TECHNICAL BULLETIN INDEX
Sorted by Bulletin Number
06/25/86

DATE: January 16, 1985
REVISION DATE: February 13, 1985
BULLETIN NO.: 6000:1
PRODUCT: 26-6021/2 (Tandy 6000)
26-6014 (8 MHz CPU upgrade kit)
SUBASSEMBLY: 8 MHz 68000 CPU board

SOLDER SIDE (LAYER 4)

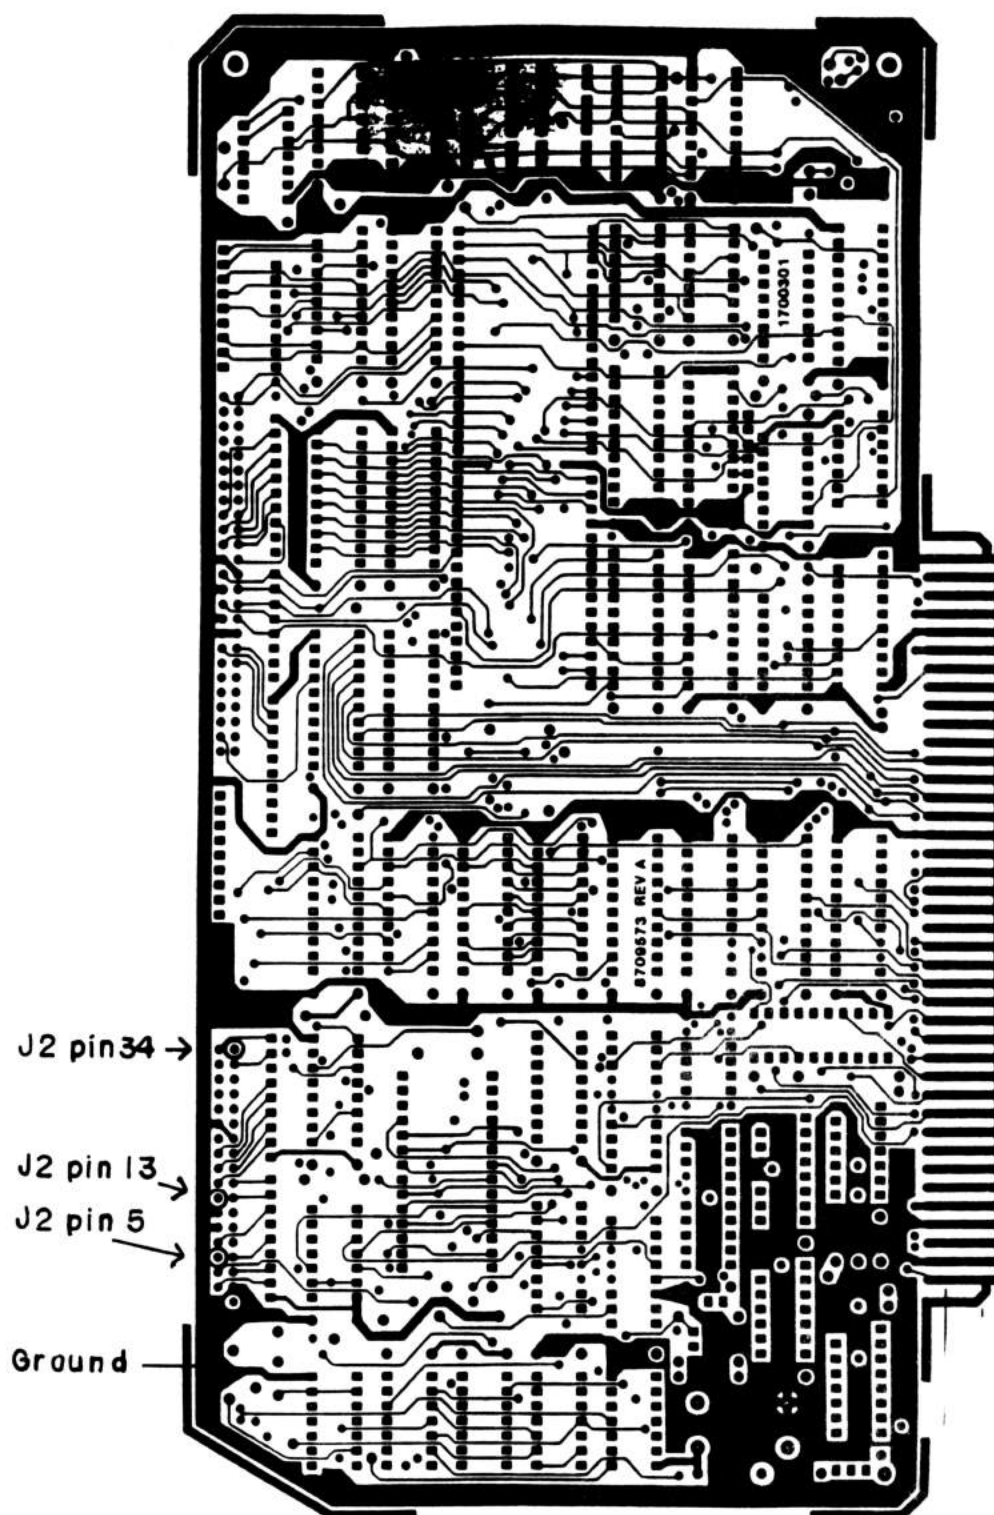
Due to an error in the artwork on early revision (Revision A) boards, a modification to insure good ground connections between the 68000 CPU board and associated memory boards is required.

Using wire wrap wire, install the following jumpers on the solder side of the 68000 CPU board:

- (1) Jumper J2, pin 5 to ground.
- (2) Jumper J2, pin 13 to ground.
- (3) Jumper J2, pin 34 to ground.

Ground may be found at the feed-throughs on the ground plane near J2 on the solder side on the board.

Figure 1

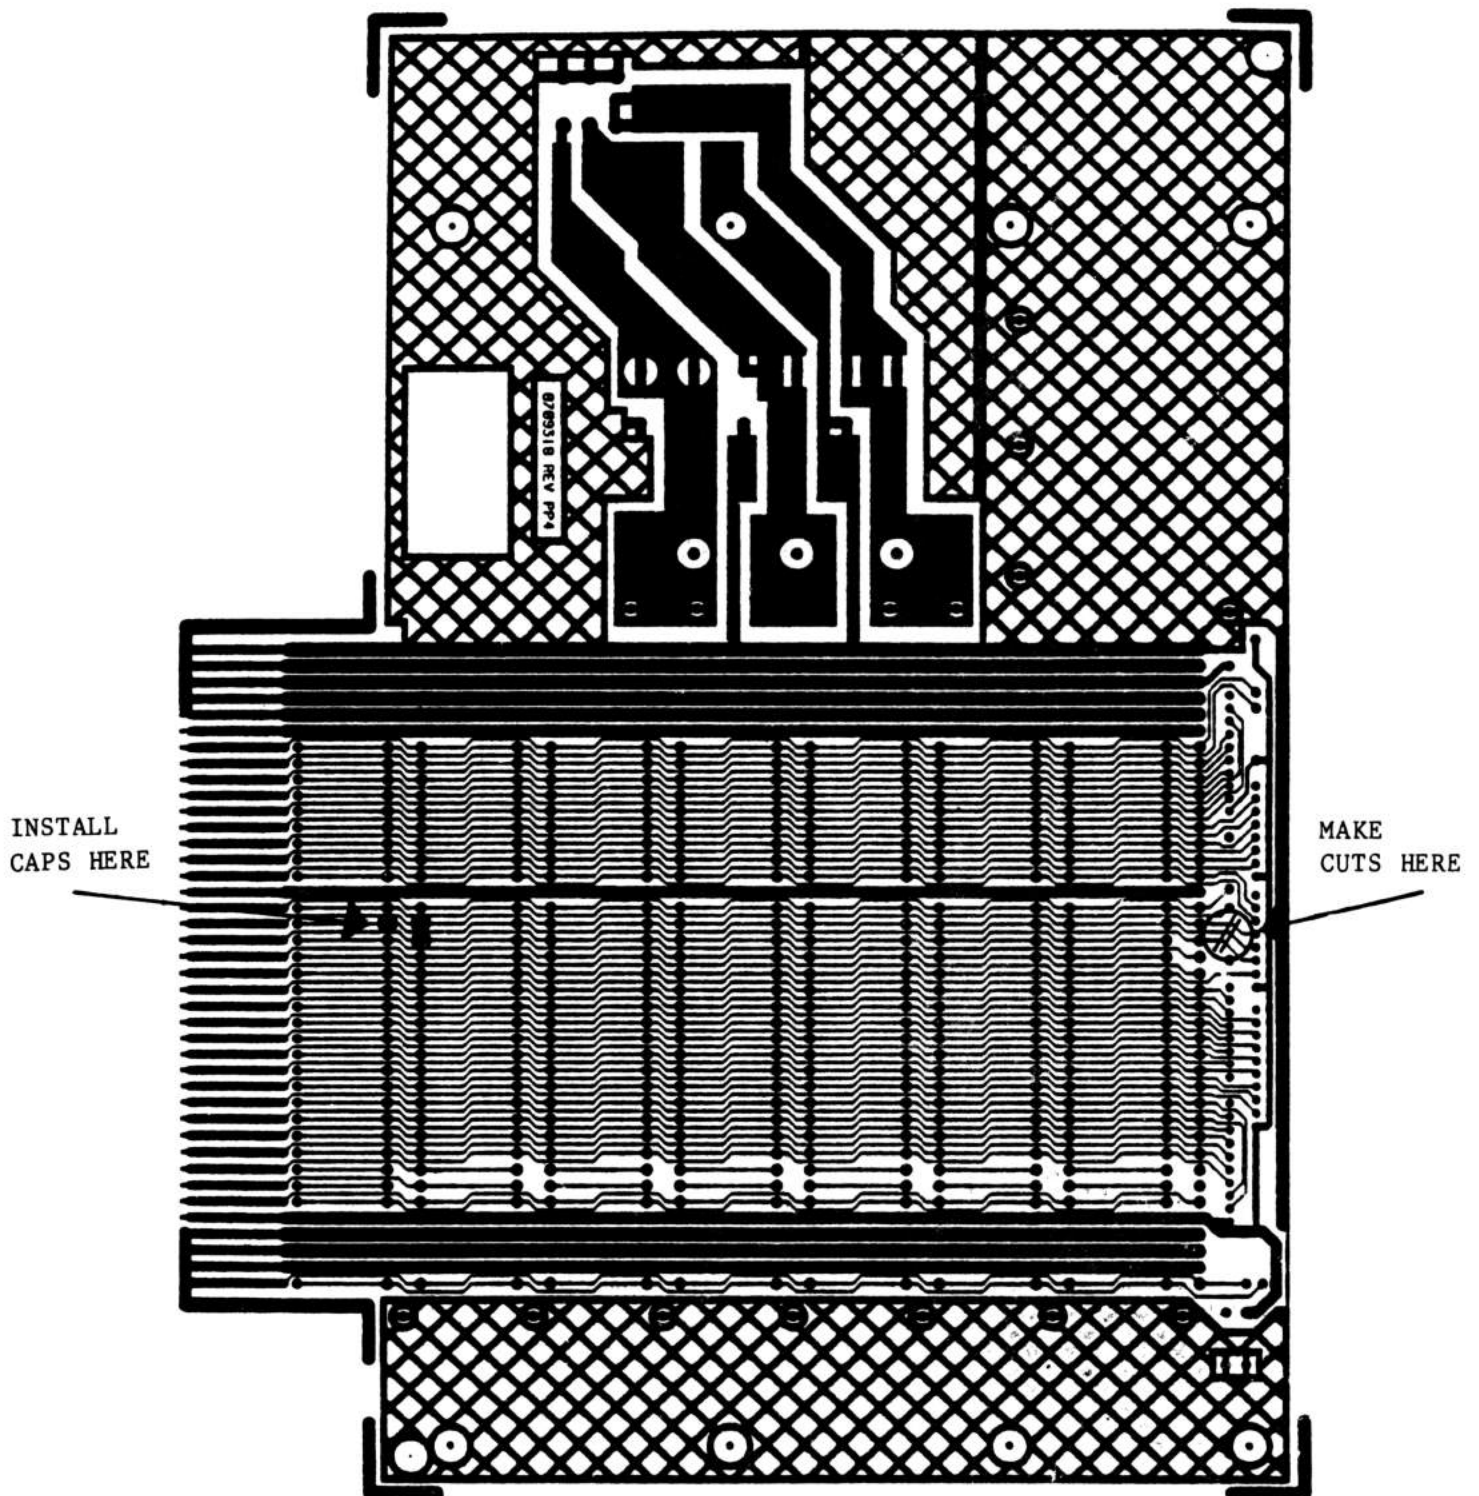
On mother boards of revision levels prior to Rev. B, pins 3, 4, and 5 on resistor pack R6 need to be cut.

On mother boards of revision level Rev. B or later, pins 4, 5, and 6 on resistor pack R6 need to be cut.

On boards of all revision levels, three (3) 220 pf caps should be jumpered from pins 44, 45, and 46 to ground on the bottom-most connector. These pins correspond to the traces cut on the resistor pack R6. See Figure 1 for clarification. The capacitors needed for this modification may be ordered as:

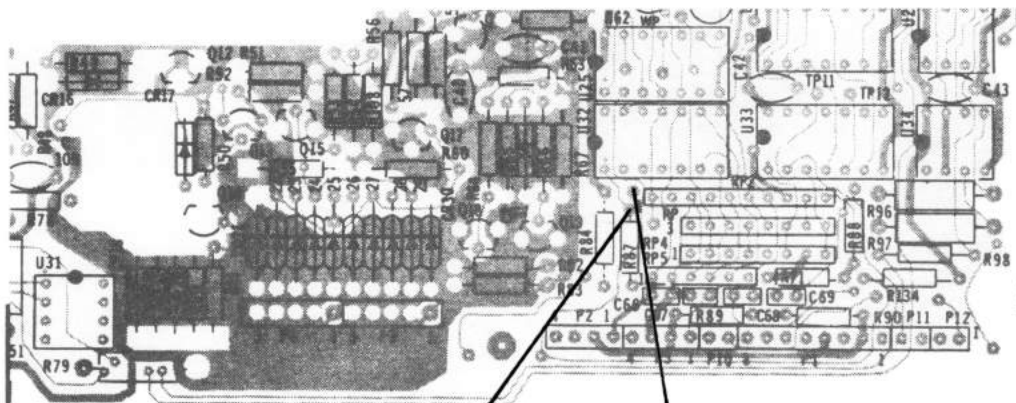
DISCUSSION: An addressing problem exists with Tandy 6000s due to slow multiplexers on the main logic board. U52, U53, and U79, three 74LS157 IC's, are misaddressing memory causing BOOT ERROR MF.

PROCEDURE: Remove the three 74LS157 IC's and replace them with 74S157 IC's or 74F157 IC's. The part numbers for these IC's are below.

74S157 MX-6112 26-5103
74F157 MX-2135 26-6014/5 or 26-6021/2
